1 HVAC PLAN
M1.1a SCALE: 3/32" = 1'-0"

DATE	REVISION
1 07/28/21	ADDENDUM NO. 2

PROJECT TITLE
KROGER STORE U606

SHEET NO.
M1.2a

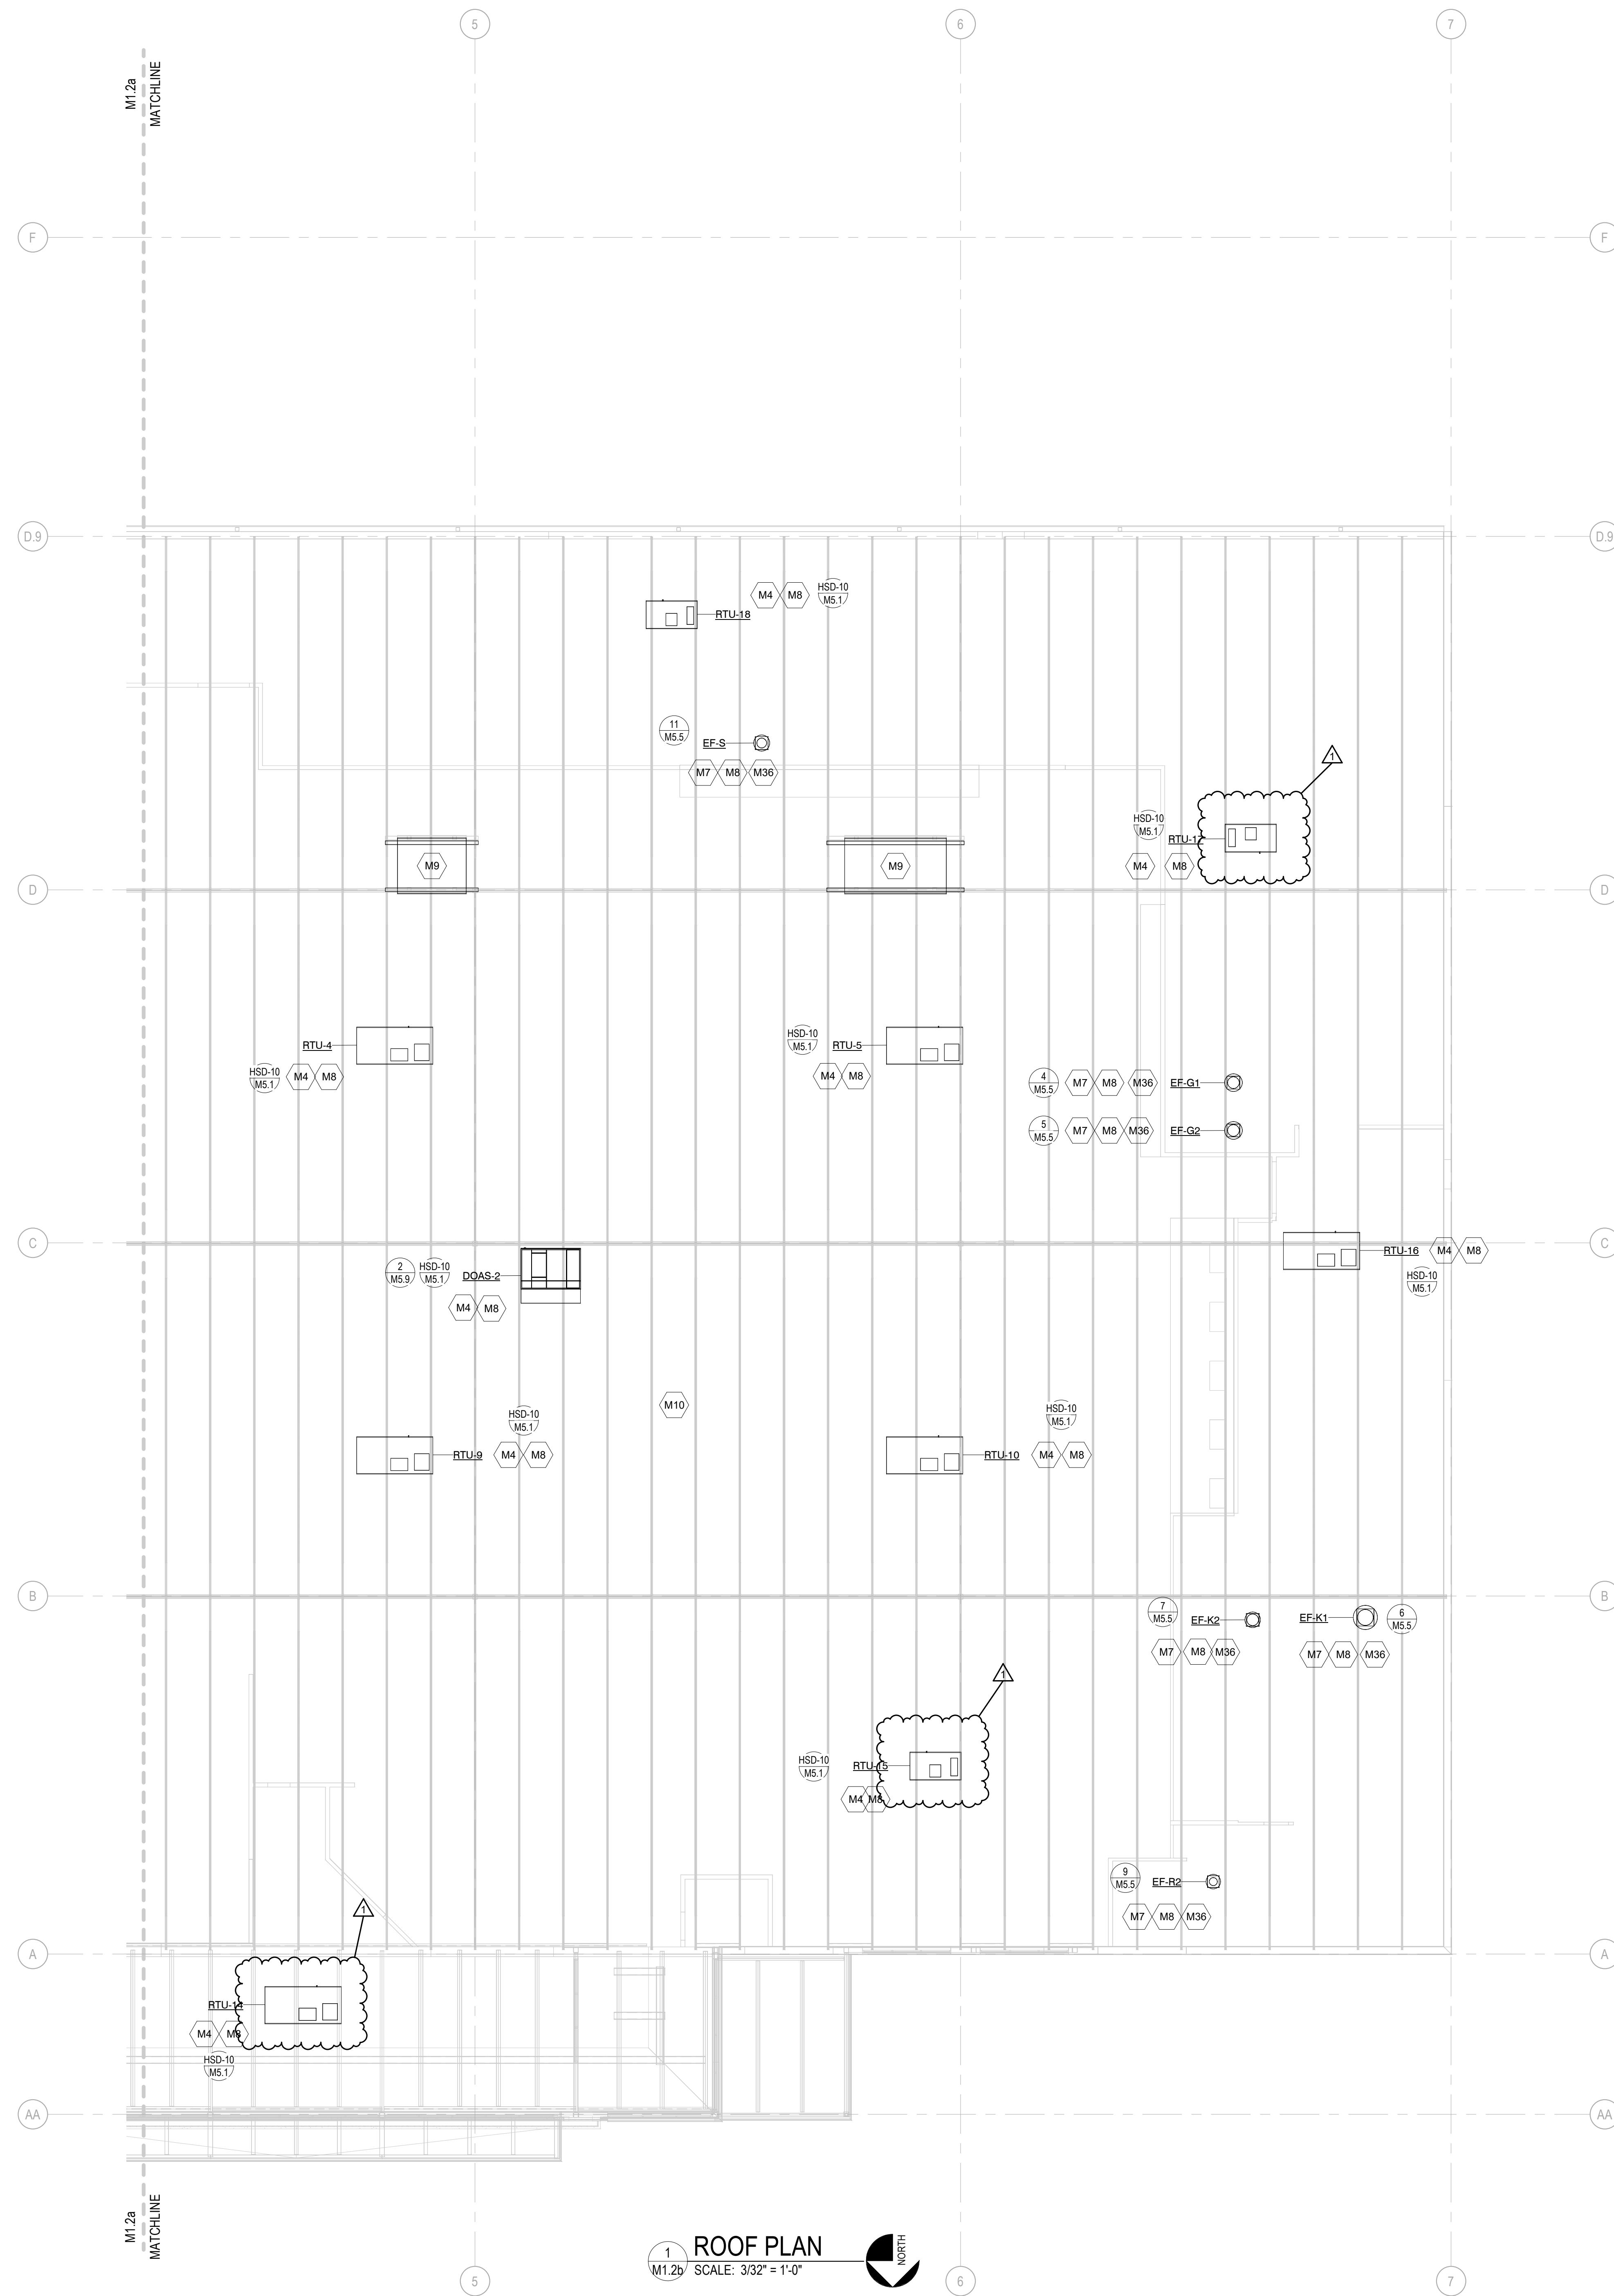
REMOVED GAS PIPING FROM PLAN. REFER TO P1.3a and P1.3b

SHEET NO.
M1.2b

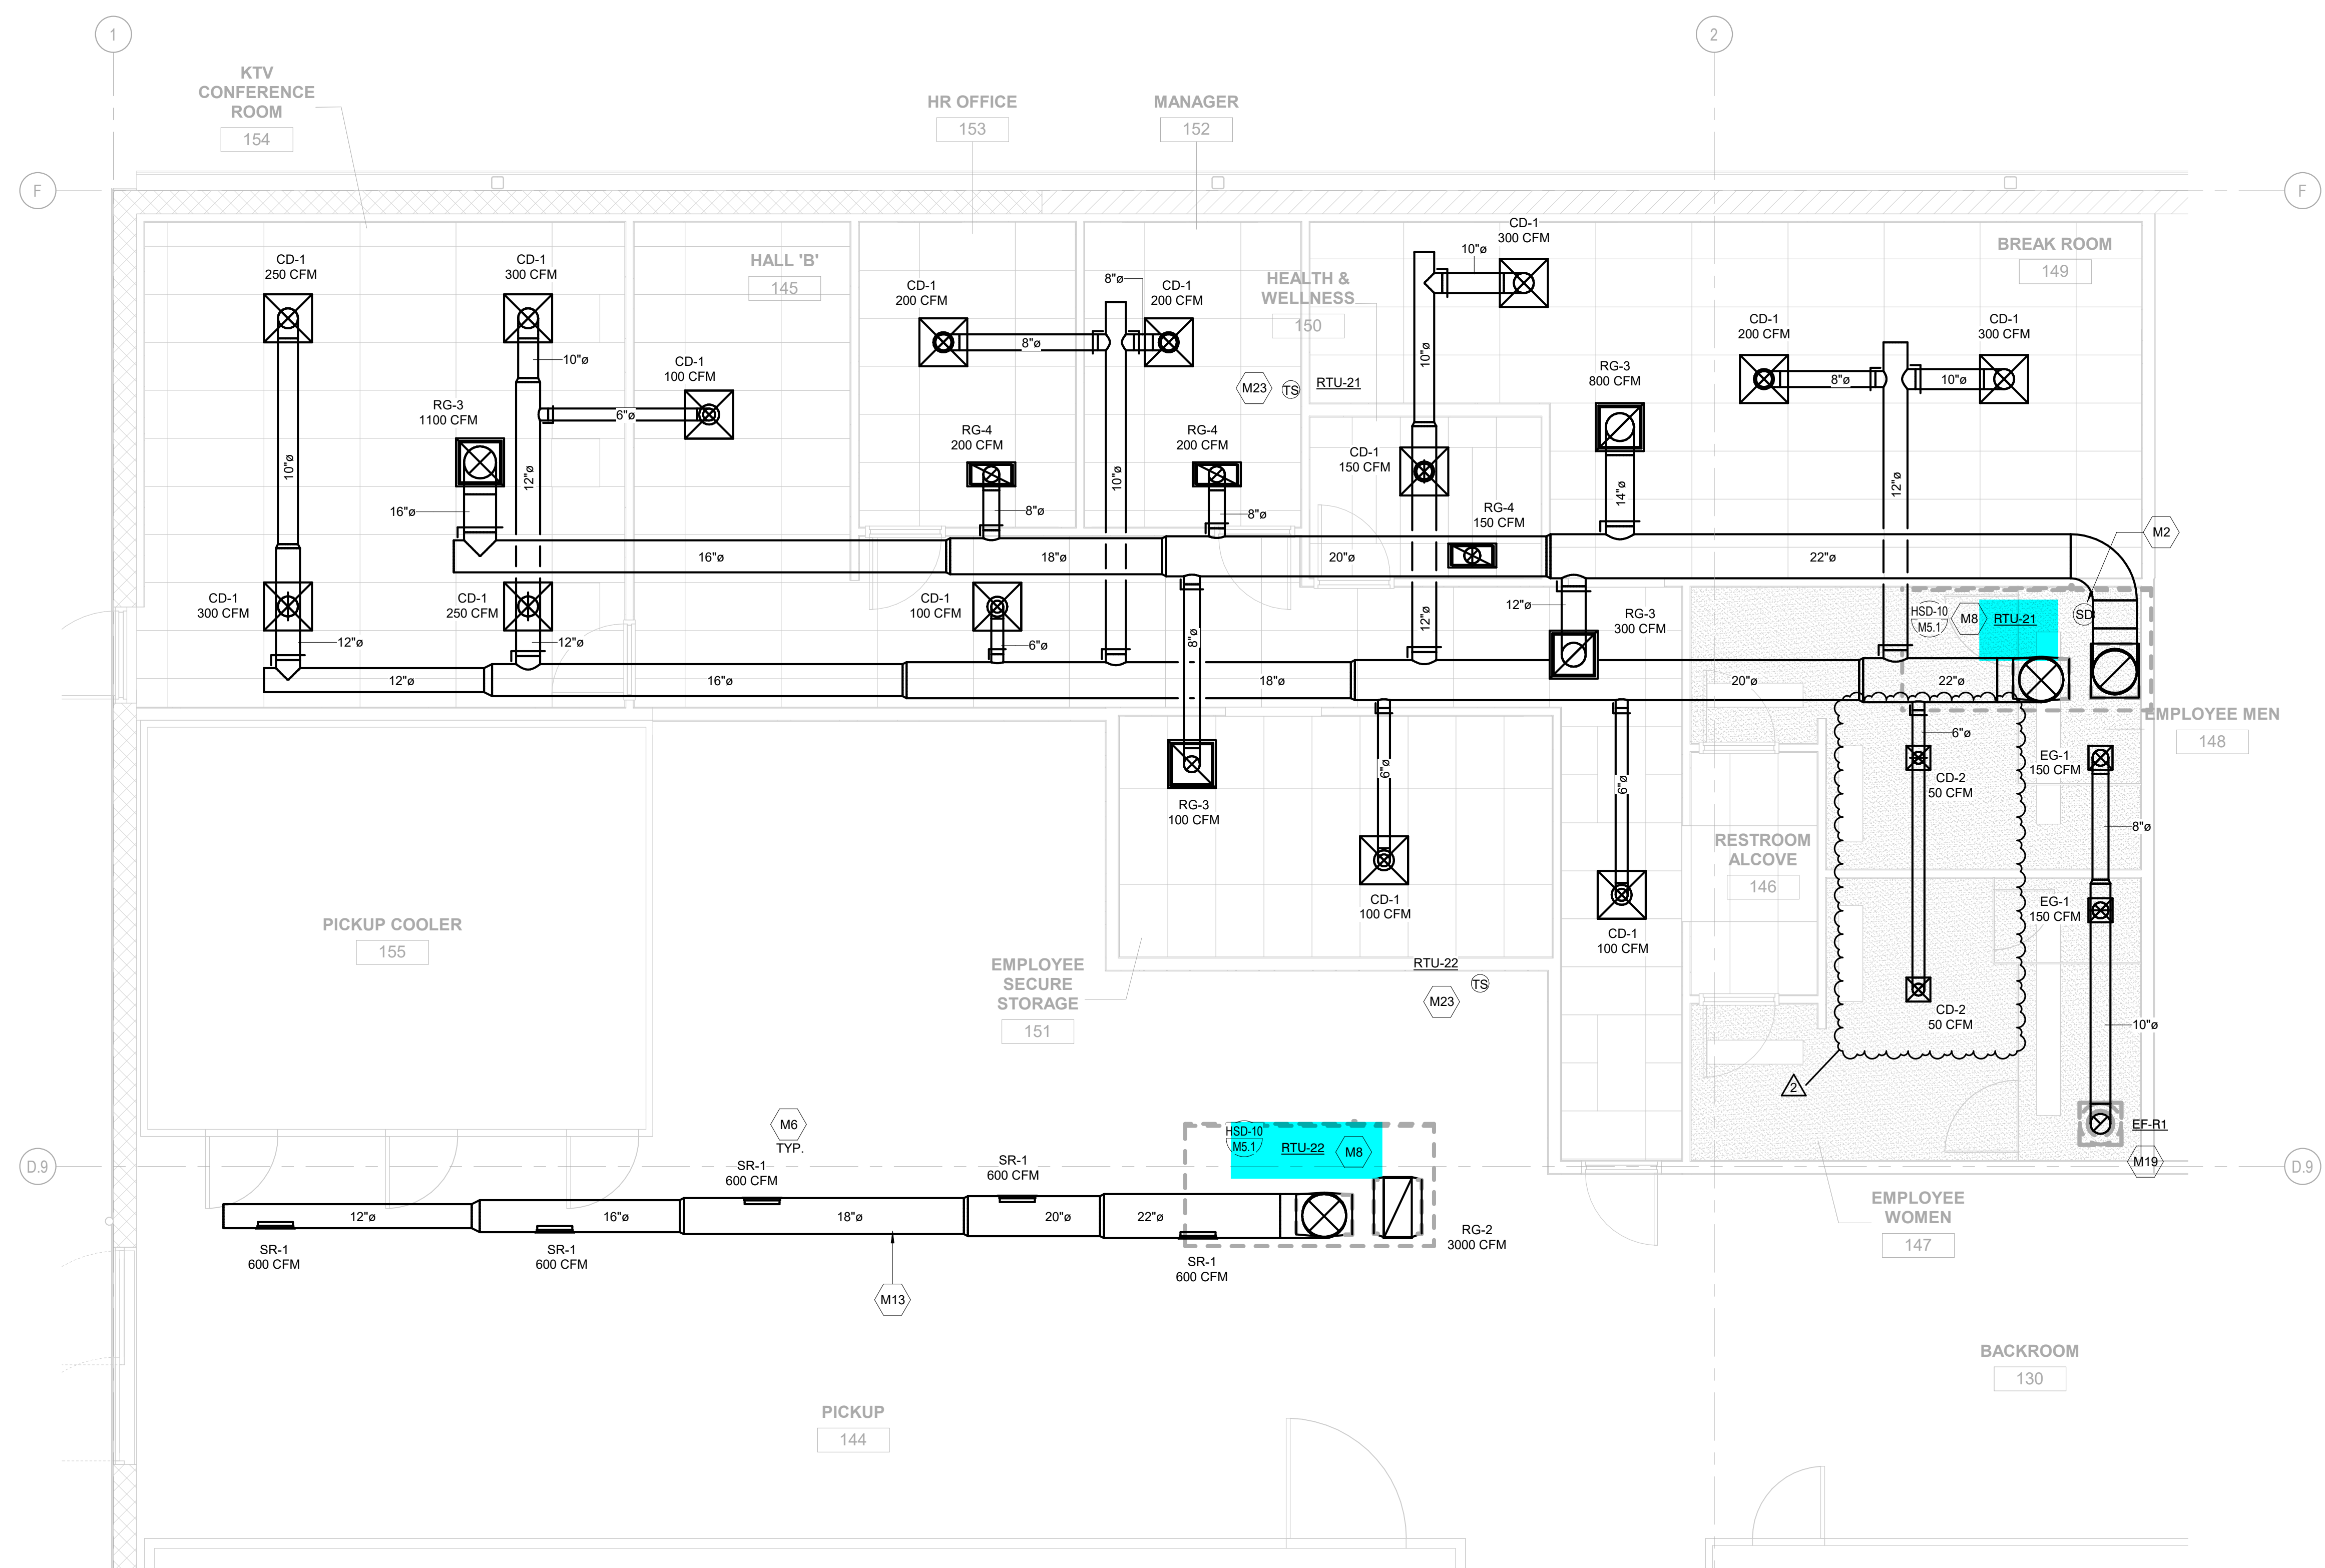
REMOVED GAS PIPING FROM PLAN. REFER TO P1.3a and P1.3b
